Midland Service Bulletin #20111010

SUBJECT: Vented Ball 520-30-MO For Assembly in A-520 & A-522 Series Ball Valves

REPLACES: All 520-3-MO balls

Top view of ball shown

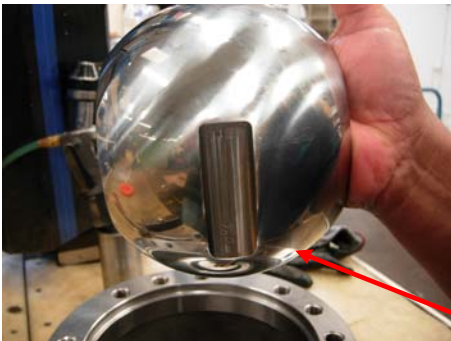
As part of Midland's practice of continuous improvement, we have made a change to our bottom outlet ball valve. The previous ball (p/n 520-3-MO) is replaced with a new ball (p/n 520-30-MO). The new ball is a direct replacement for the previous 520-3-MO. No additional parts are needed.

The new vented ball allows pressure trapped in the interior of the valve to escape towards the tank.

The new vented ball (p/n 520-30-MO) **MUST BE INSTALLED WITH THE SMALL VENT HOLE POINTING TOWARDS THE TANK.**

The vented Ball 520-30-MO should be assembled in valve with vent hole facing top of the valve which is TANK CAR SIDE. When the valve is closed the hole is visible from top. The reason for vent hole is to release internal pressure from valve to tank.

Notice marking on Ball next to vent hole
"TANK CAR SIDE ONLY"

Vent hole
